METROPOLITAN GOVERNMENT OF NASHVILLE AND DAVIDSON COUNTY

STAFF RECOMMENDATION
1507 Linden Avenue
July 2, 2015

Application: New construction—addition; Setback determination
District: Belmont-Hillsboro Neighborhood Conservation Zoning Overlay
Council District: 18
Map and Parcel Number: 10513008300
Applicant: Michael Ward/ Tyler LeMarinel, Allard Ward Architects
Project Lead: Melissa Baldock, melissa.baldock@nashville.gov

Figure 1. 1507 Linden Avenue

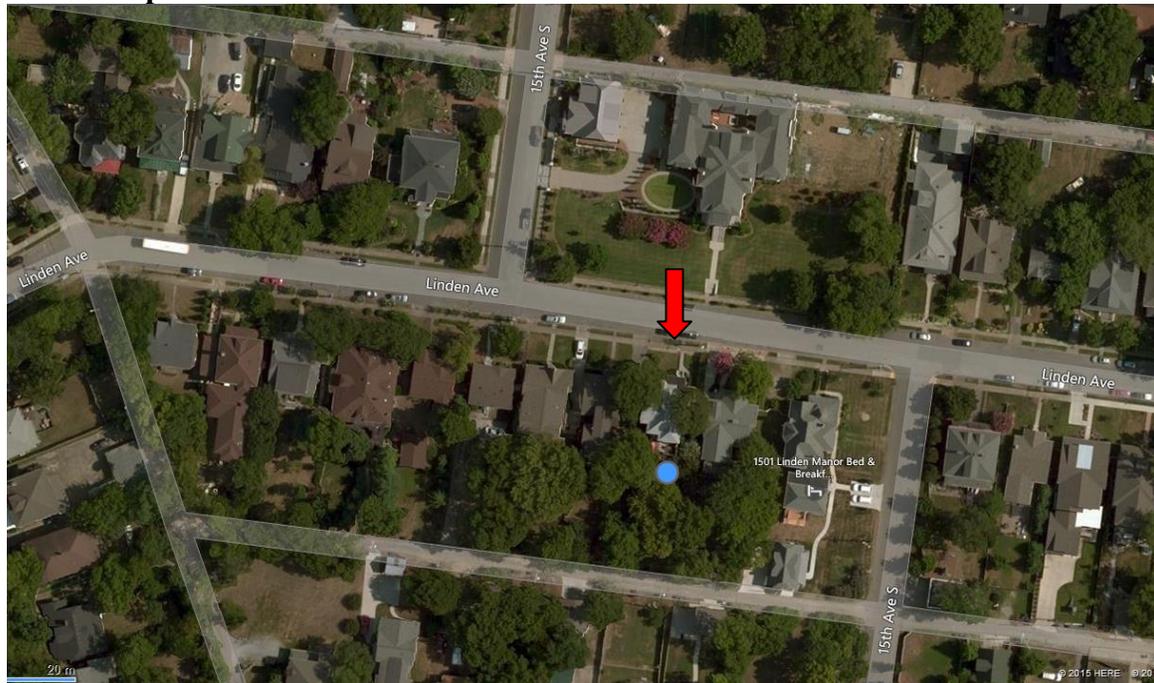
Background: 1507 Linden Avenue is a c. 1910, two-story house that contributes to the historic character of the Belmont-Hillsboro Neighborhood Conservation Zoning Overlay (Figure 1). In 2014, MHZC staff issued an administrative permit for an addition to the house, but that addition was never constructed. This application represents a new application and a new design for an addition.

Figure 2. The new window openings will be added behind the bay and will not be visible from the street

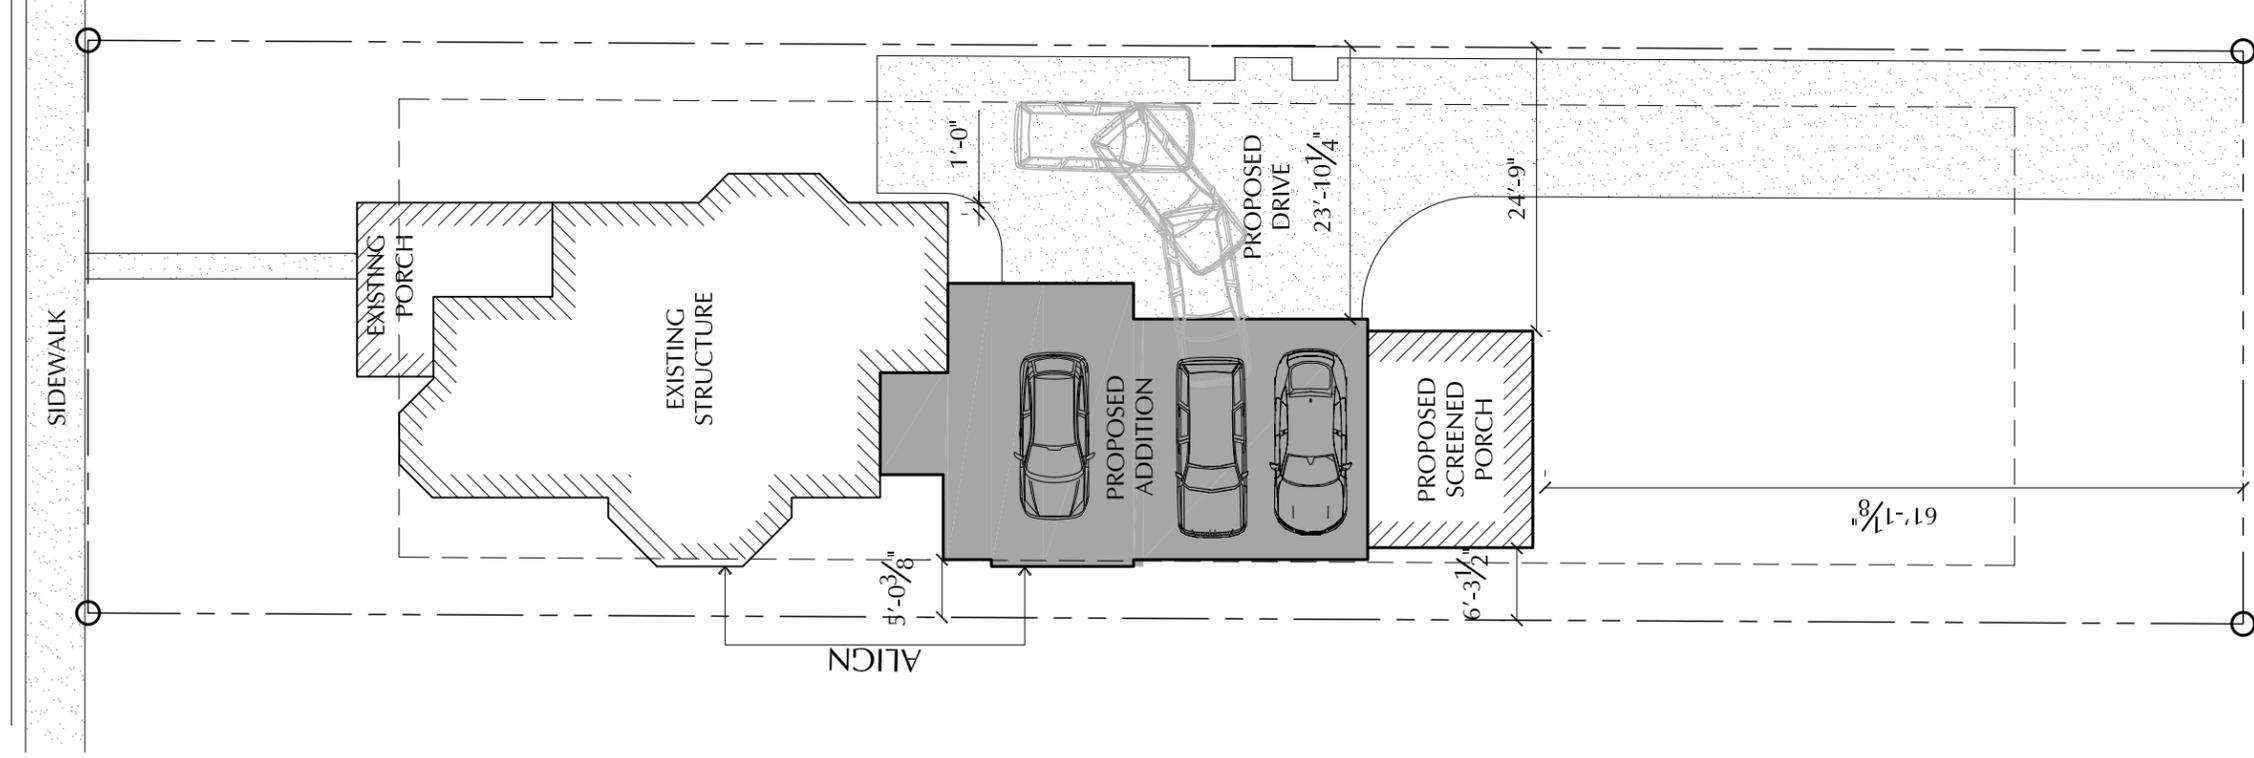
Proportion and Rhythm of Openings: The applicant is planning to add window openings to the right façade of the historic house, at the back of the house. Staff finds these new window openings to be appropriate because they are located behind the two-story bay, and that portion of the façade is not visible from the street (Figure 2).

Site Layout Plan

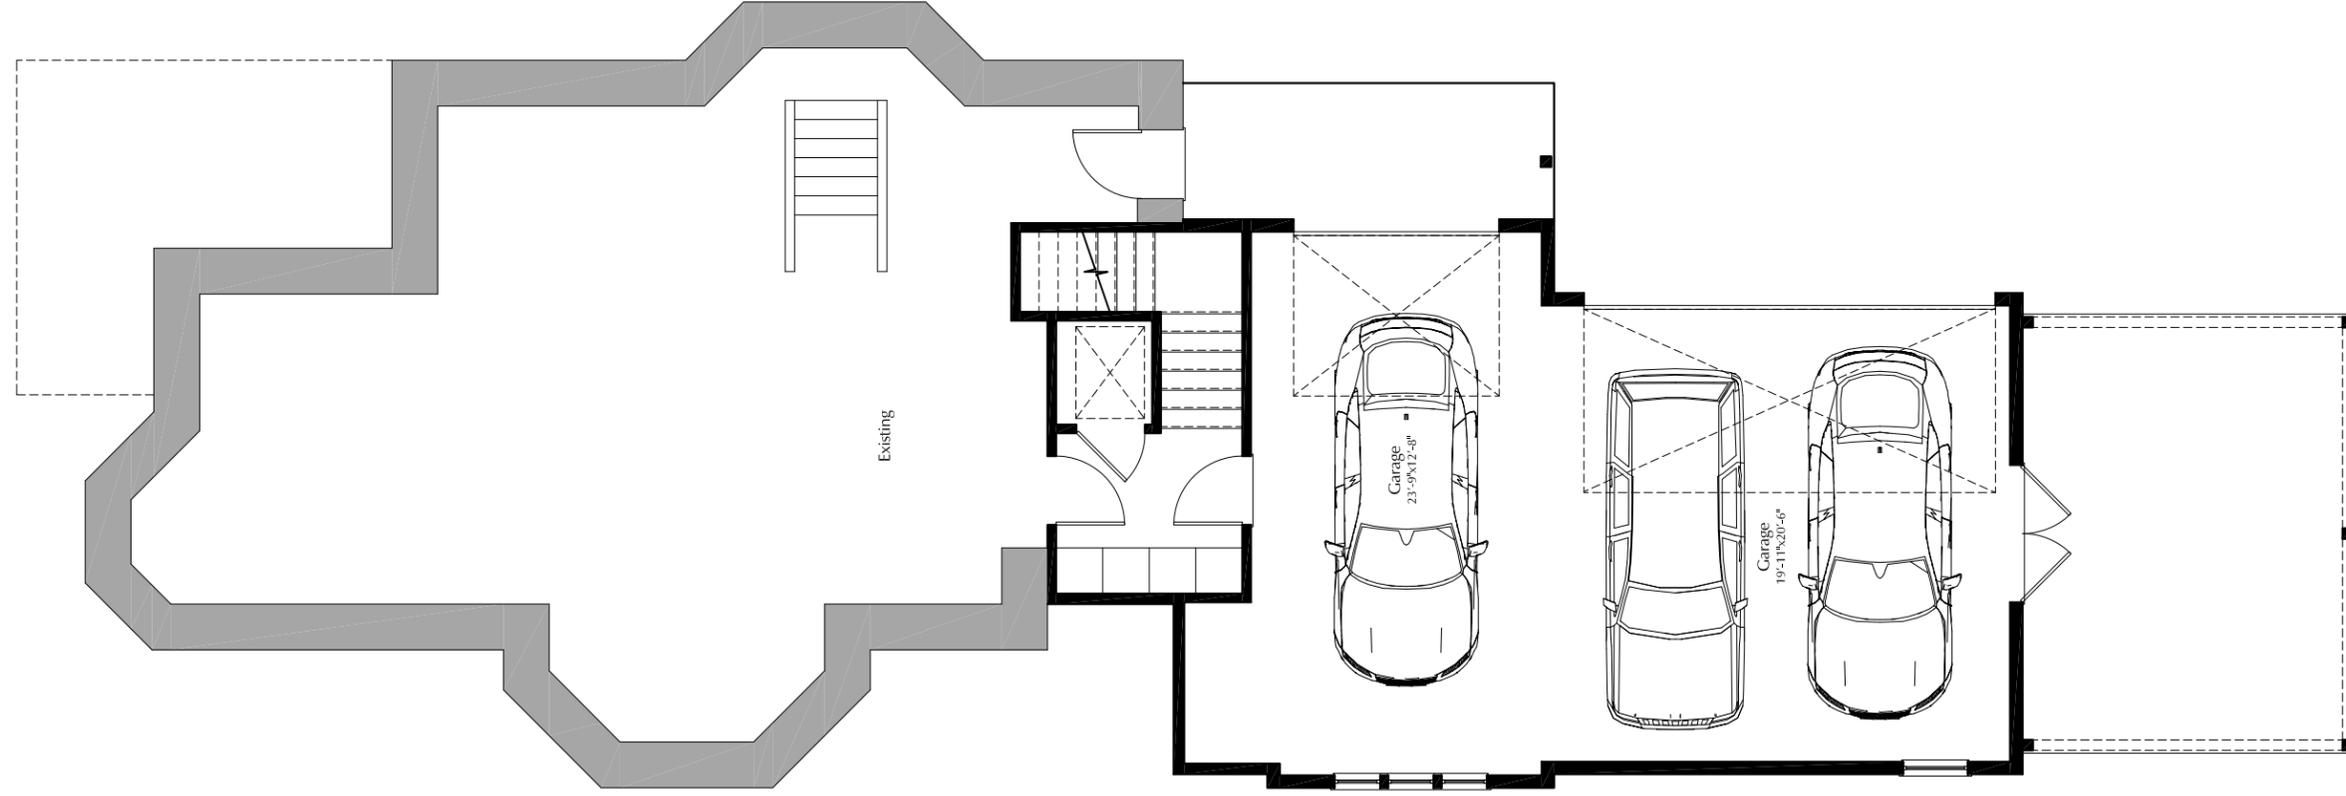
Setback & Rhythm of Spacing: The addition will be over fourteen feet (14') from the left side property line, thereby meeting that side setback. The addition does encroach on the side setback on the right side. A twelve foot, nine inch (12'9") deep bay will encroach approximately six inches (6") into the required five foot (5') left side setback. Staff finds that this encroachment is appropriate because the bay will be no wider than the historic house's side bay, and it will only extend approximately six inches (6") into the required setback. In addition, most of the addition will meet the require side setback, and only the bay will encroach on the setback. In addition, an uncovered staircase to the rear porch encroaches on the required five foot (5') setback. Staff recommends approval of the setback determination, and finds that the proposed setbacks and rhythm of spacing meet Sections II.B.1.c. and II.B.2. of the design guidelines.
